Short Block Modifications - 43 and 48 Cubic Inch Engines

SERVICE BULLETIN

#85-2

SUBJECT: Vapor Lock Symptoms - Models 226, 446, 448 Tractor and
648 Loaders with Onan Engines

FIGURE 1. PTO SPACER

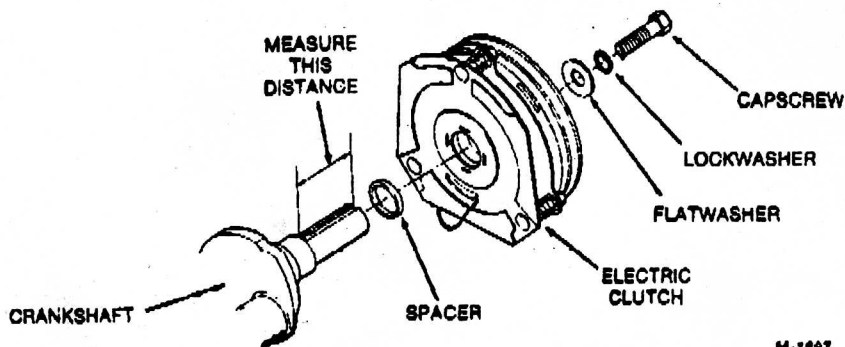
When replacing an engine that has a crankshaft of 1-7/16" diameter and a stub end length of 3-1/16" (measure stub end length, Figure 1), the supplied crankshaft spacer must be installed as shown in Figure 1. If replacing an engine with a stub end length of 2-5/8", do not use the spacer. If installing an electric clutch on the crankshaft, the air gap must be adjusted. Refer to the equipment manufacturer's service manual for the proper adjustment procedure.

FIGURE 4. PULSE PICK-UP HOSE

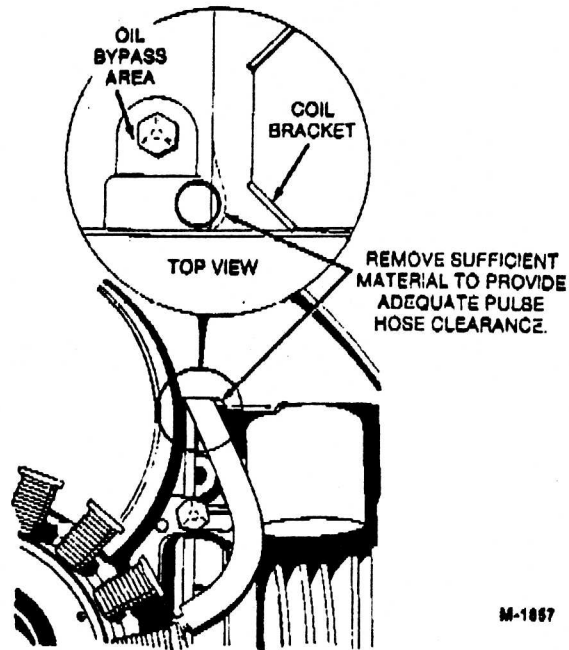
Some modifications may be required to allow your sheet metal to be used with the new spec short block. Some short blocks are equipped with the pulse pick-up hose on the gearcase assembly which must be routed to the pulse fitting on the carburetor. Cut out sufficient material in the corner where the front blower housing meets the coil bracket to allow the hose to be routed along the gearcase cover and over the oil bypass area to the carburetor without being pinched. See Figure 4. Avoid cutting sharp notches in the sheet metal to prevent cracking and smooth the rough edges to avoid cutting or damaging the hose during use.

FIGURE 5. CYLINDER AIR HOUSING

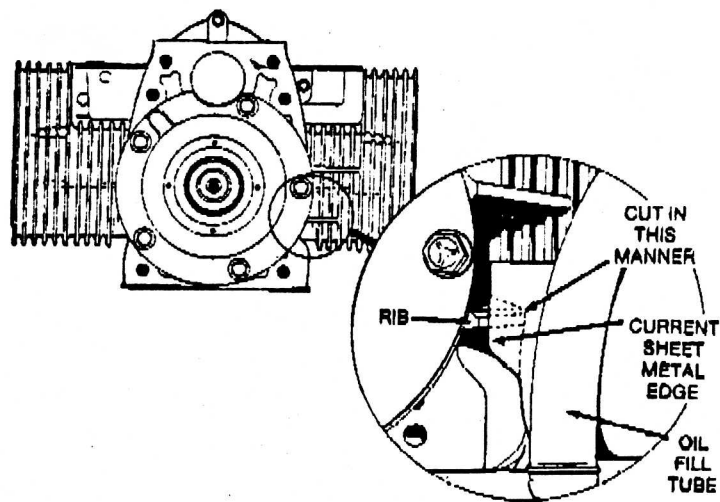
The left side cylinder air housing may interfere with a rib that has been added to the block casting. See Figure 5. Extend the radiused corner up to clear the rib. Again, avoid cutting sharp notches and smooth the rough surface.

FIGURE 1

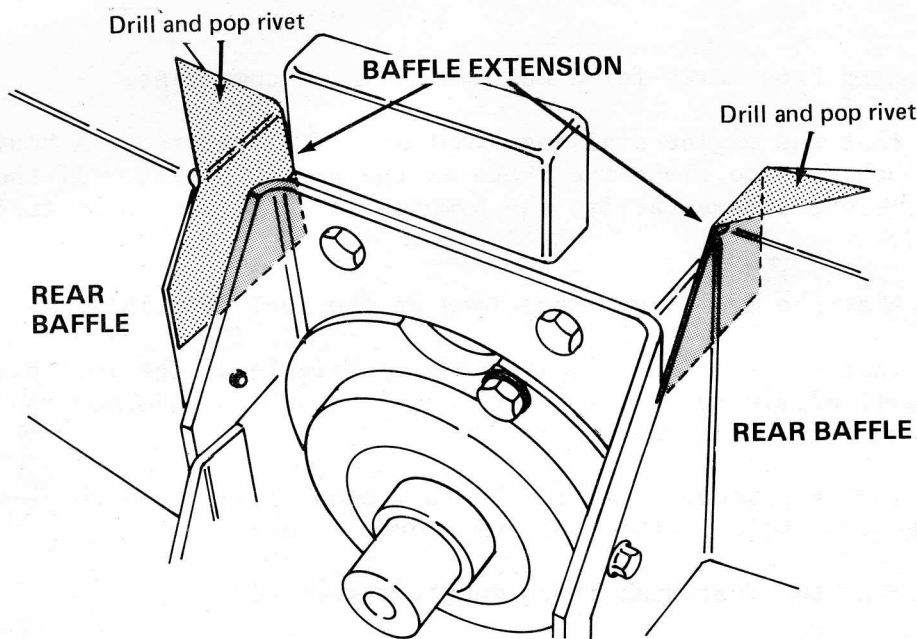
2. Loosen (Do Not remove) the screws which secure the rear cylinder baffles to the pump mounting bracket.
3. Slip the rear cylinder baffle extensions in position. Make certain the corners are closed off. See Figure 1. Tighten the screws.

4. Drill through the rear cylinder baffles and baffle extensions and pop rivet together.

FIGURE 1. (A) **WRONG**

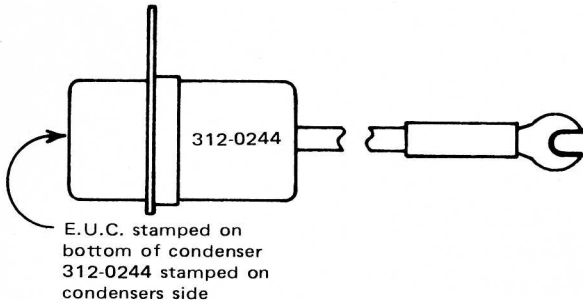
- 1] Some C 23855 condensers manufactured by E.U.C. (identified by E.U.C. stamped on the bottom and 321-0244 stamped on the side of the condenser) can have an improperly soldered condenser lead. (See FIGURE 1. (A).
- 2] Some C 23855 condensers manufactured by Phelon (identified by 312-0246 stamped on the bottom) can breakdown in applications when condenser temperature exceeds manufacturer's guidelines. See FIGURE 1. (B).

4] Order a sufficient quantity of the new C 29479
condensers for your stock and for the C 23853
ignition assemblies in your stock from:
